TECHNICAL BULLETIN

Rattle After Start – Upper Timing Chain – Install Revised Tensioner

12-61

MODEL All AJ6

ILLUSTRATION 2

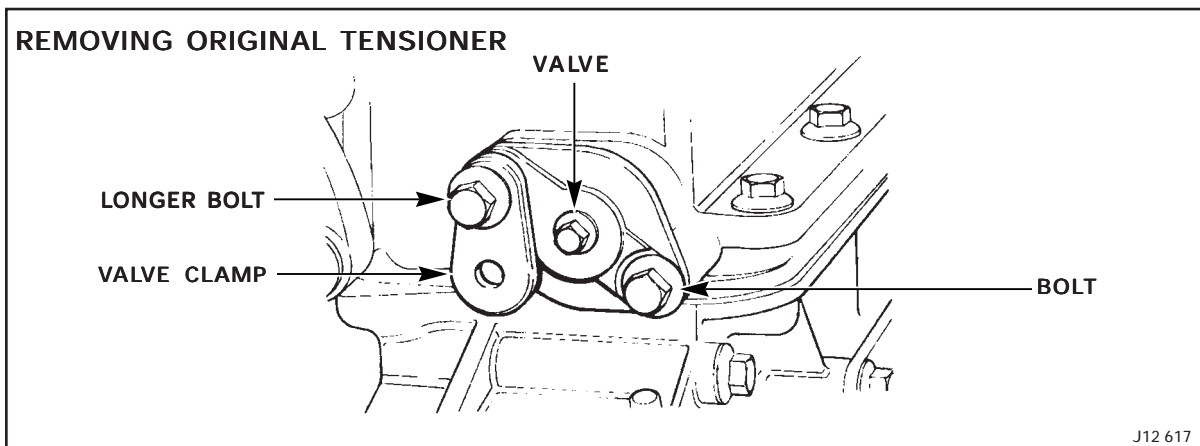
A revised tensioner with an integral oil reservoir has been introduced to overcome this condition starting with the following engine numbers:

5. Place the O-ring on the revised tensioner (Illustration 2) and lubricate it with engine oil.
6. Check that the mechanical tensioner within the piston is fully retracted (fully closed position.)
7. Install the tensioner assembly with a new gasket on the engine. Ensure that the arrow is pointing up and that the slotted head of the piston is aligned with the tensioner blade. (The bolt listed in the part information replaces the longer bolt previously discarded.) Torque the bolts to 16.2 - 20.7 lb. ft. (22 - 28 Nm.)

ILLUSTRATION 1

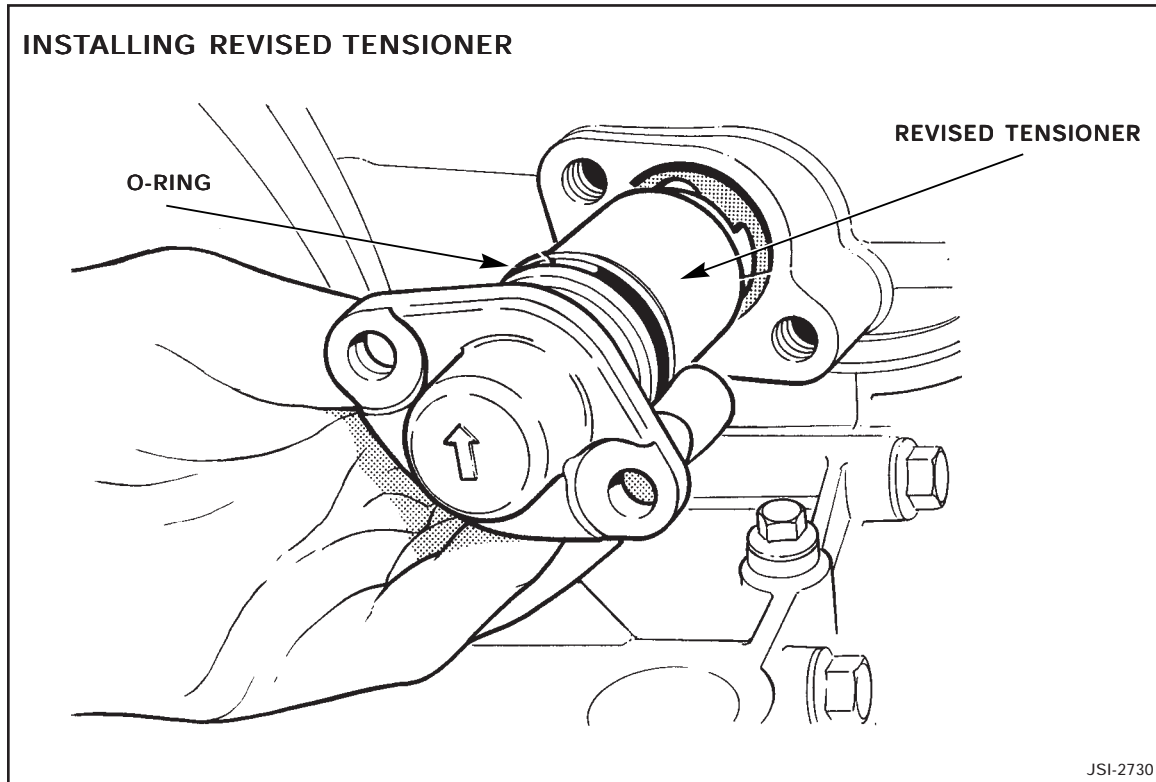
1. Remove the fuel pump relay and run the engine at idle to depressurize the fuel system.
2. Remove the longer bolt (Illustration 1), remove the valve clamp and remove the valve.
